Environmental Review Team Report

UCEPI Site  
Mansfield, Connecticut

ENVIRONMENTAL REVIEW TEAM REPORT  
ON  
UCEPI SITE  
MANSFIELD, CONNECTICUT

The Eastern Connecticut Environmental Review Team was asked to prepare an environmental assessment for a proposed industrial/research park in the Town of Mansfield. The project site is approximately 400 acres in size and is located north of the University of Connecticut campus. The property is bounded by Route 44a on the north, Route 195 on the east, North Eagleville Road on the south and Hunting Lodge Road on the west. The property is presently owned by a private holding company known as UCEPI (University of Connecticut Educational Properties, Inc.). The Sunrise Development Company has prepared the concept Master Plan for the proposal.

# Master Plan

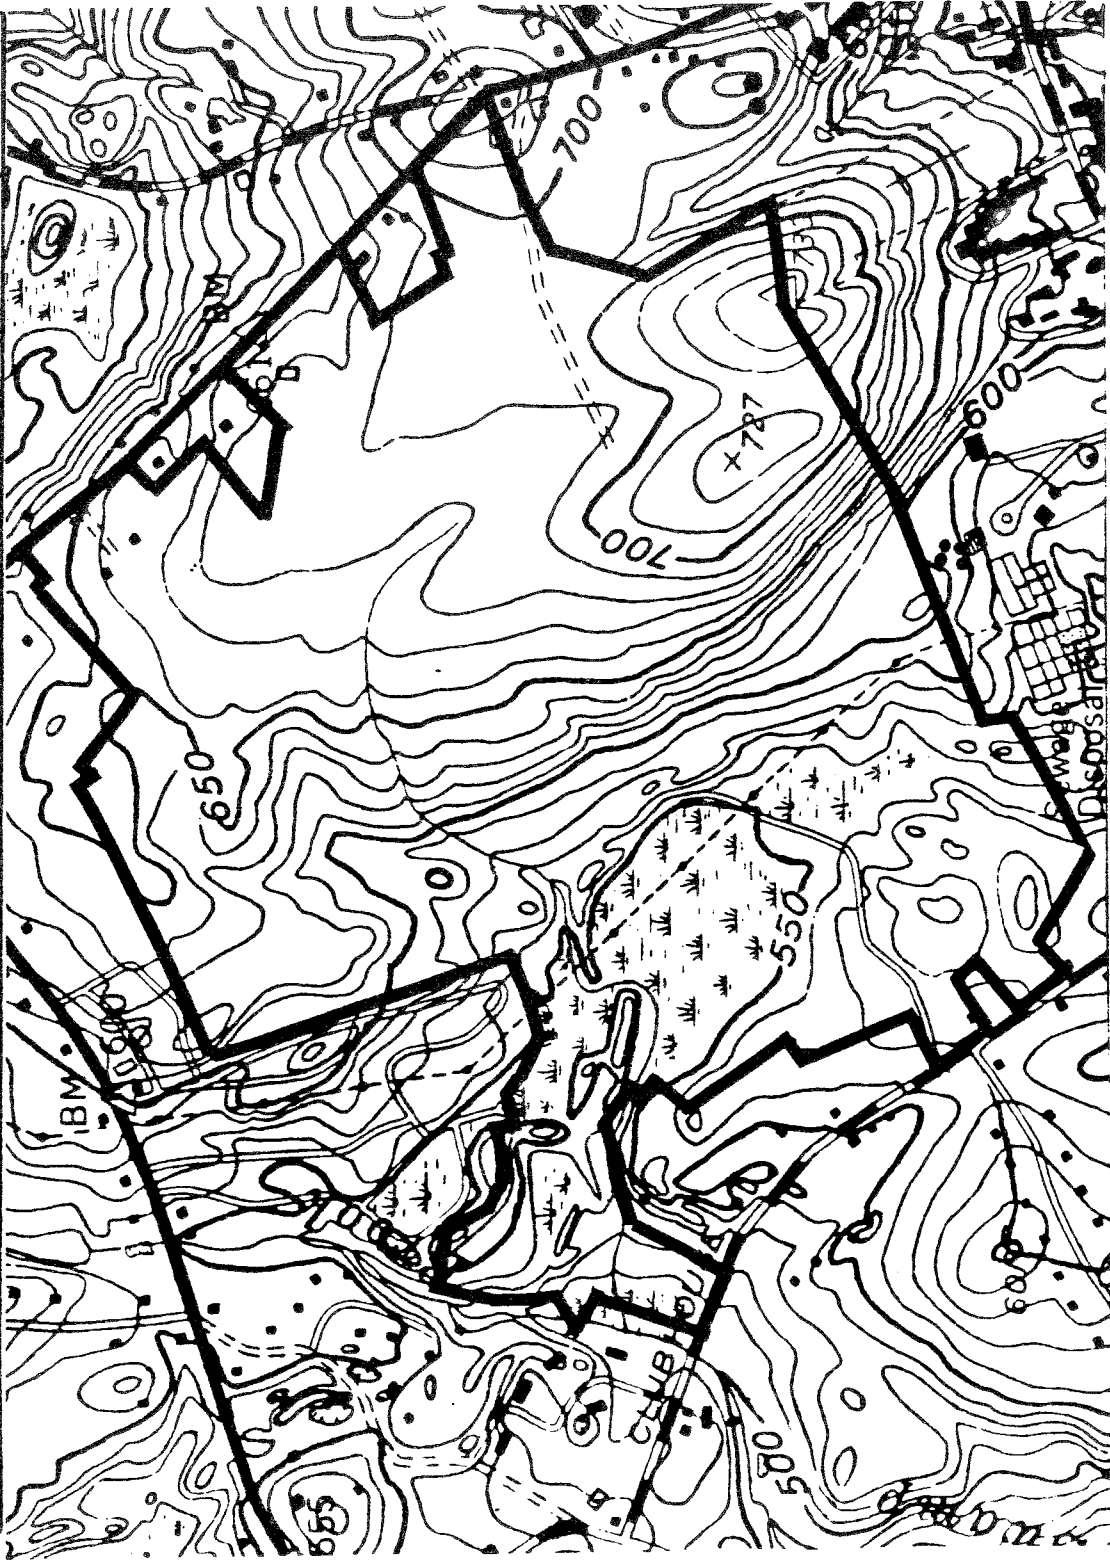
The proposed plan calls for 113 acres of the site to be used for the research/industrial complex, 7 acres for office space, 20 acres for the hotel/conference center, 18 acres for student housing, 69 acres for multi-family residential use, 30 acres for mobile homes, 33 acres for agricultural lands and 87 acres to remain as open space. All facilities would be served by on-site water supply (UCONN System) and the UCONN sewage treatment plant.

The Team is concerned with the impact of this development on the natural resource base of this site. Although many severe limitations to development can be overcome with appropriate engineering techniques, these measures can become costly, making a project financially unfeasible. This 400 acre site has a number of physical constraints which may restrict development; these concerns as well as planning issues impacting on the Town, are discussed in detail in the following sections of this report. One of the major concerns related to development of this site is the loss of Prime Agriculture Soil (as classified by the USDA Soil Conservation Service) currently in use here. It would appear that more creative planning techniques could have been used during the design/layout stage of this project. Techniques such as "clustering" or shared parking facilities, etc., do not appear to have been considered by the developer. A letter from the Tolland County Soil and Water Conservation District to the Commissioner of Agriculture (see Appendix) also indicates that this proposal is a direct contradiction of the Connecticut Plan of Conservation and Development. The Team feels that these issues should be investigated more fully by both the Town and developer. In a time of dwindling farmland in this state, needless obliteration of 60± acres of prime agricultural soils already in State ownership, should not be considered a viable development alternative.

# Drainage Areas

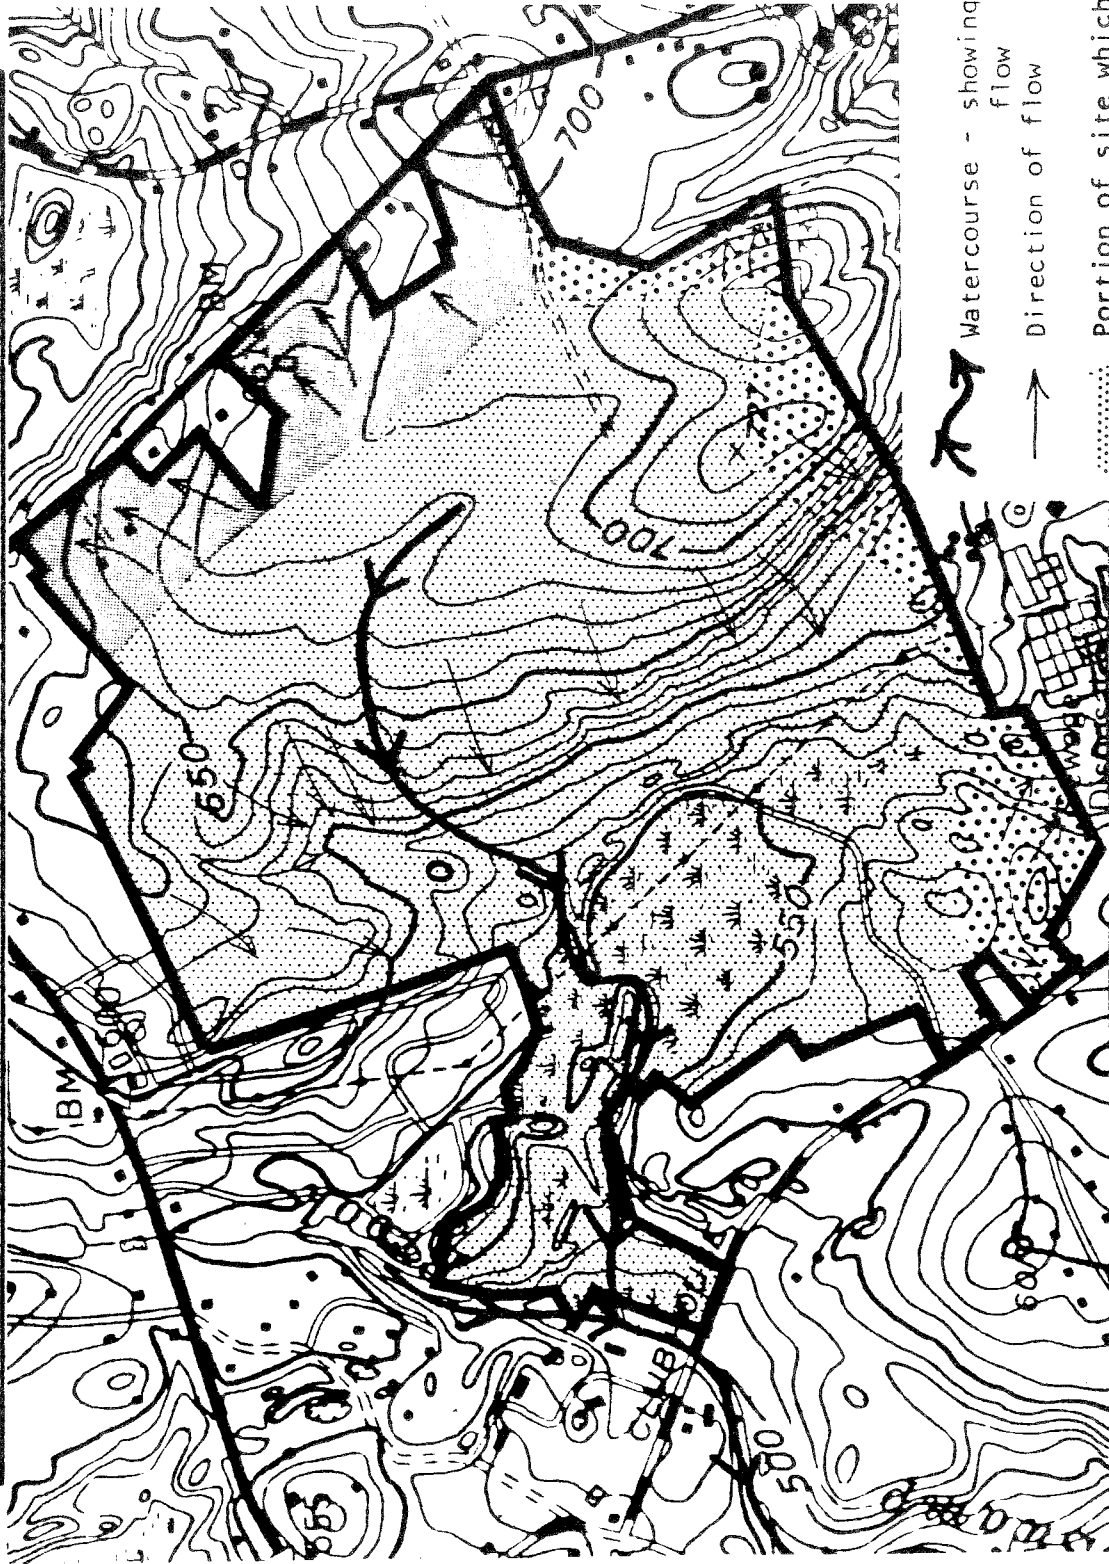
Both industrial-commercial and residential development of the site would be expected to increase the amount of runoff during periods of rainfall. This increase would result from soil compaction, removal of vegetation, and placement of impervious surfaces (roofs, parking lots, driveways, roads), over the soil. Since the commercial and industrial uses would tend to require more impervious surface area, for parking lots and larger buildings, the runoff increases for that type of development would tend to be higher than for residential development. In this regard, it is important that a storm water management plan be prepared for this site prior to any development. In addition, it is recommended the applicant submit detailed hydrological information on pre and post-development runoff volumes and peak flows from the property. Estimates should be provided for a 10, 25, 50, and 100 year design storm. The best way to handle increased runoff volumes following development of the site would be through the use of on-site detention basin or basins. In addition, a stormwater detention basin might also serve a sediment retention function. If sediment does accumulate in a basin(s), it will have to be removed periodically in order to assure that the runoff storage capacity of the pond is not seriously diminished. In this regard, consideration should be given to maintenance of the basin(s) once they are constructed. Efforts should be made to locate detention basins on upland type soils rather than in wetland areas, which have some natural stormwater detention capabilities. Detailed design specifications for all stormwater control facilities, i.e., detention basins should also be submitted.
